KINGS BRANCH SUBDIVISION, PHASE TWO

APPLICATION NUMBER 18 DATE January 6, 2004

REQUEST Subdivision

DETAIL SITE PLAN

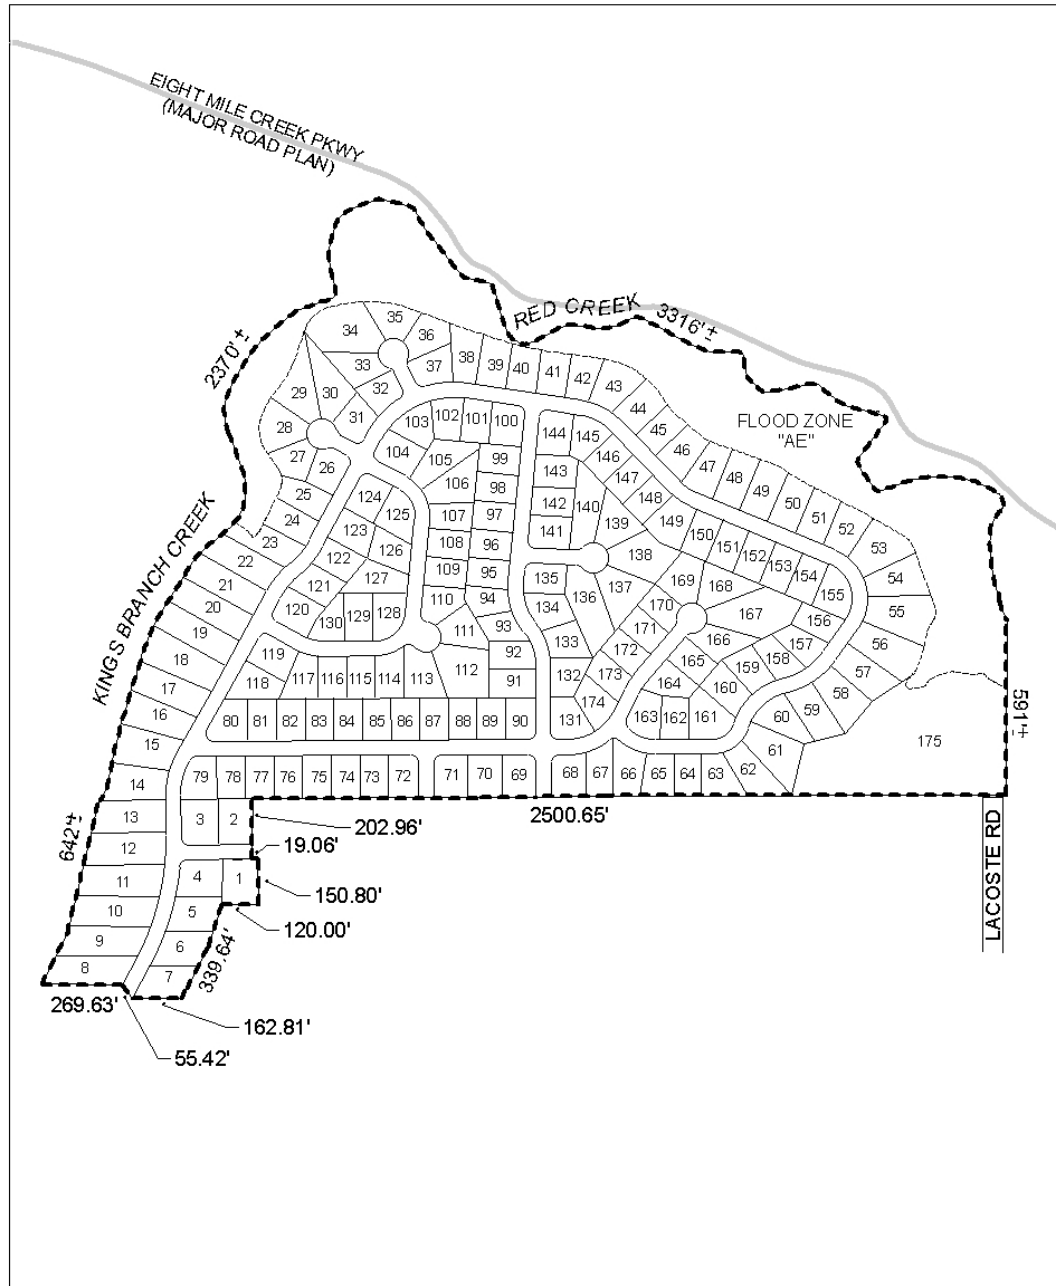
Along Eight Mile Creek is a large area that is not labeled, nor does this area have frontage on a public street. This area should be identified as a common area with a note on the final plat stating that the maintenance thereof shall be the responsibility of the property owners. Additionally, all common areas should have at least 25-feet of access to a public street.

To the west Ching Lynch Road is shown as a dead-end street; however, a turnaround is provided, and to connect Ching Lynch with the proposed streets within this subdivision would require construction of a bridge over Kings Branch Creek. As the site currently has three points of access to Moffett Road, a waiver of Section V.B.1. (street connection) would be appropriate.

Lot 175 has only 25-feet of frontage to LaCoste Road, thus a note should be placed on the final plat stating that there will be no further resubdivision of Lot 175 until the lot has additional frontage on a dedicated and improved public street.

With a waiver of Section V.B.1. (street connection) the plat will meet the minimum requirements of the Subdivision Regulations and is recommended for Tentative Approval subject to the following conditions: 1) the approval of all applicable federal, state and local agencies prior to the recording of the final plat; 2) the placement of note on the final

plat stating that the northern portion of the site may be impacted by the planned Eight Mile Creek Parkway and a study will be conducted at that time to determine the exact location of the parkway; 3) that the large unlabeled area be identified as common area with a note on the final plat stating that the maintenance thereof shall be responsibility of the property owners; 4) that all common areas have a minimum of 25-feet of access to a public street; and 5) placement of a note on the final plat stating there will be no further resubdivision of Lot 175 until the lot has additional frontage on a dedicated and improved public street.
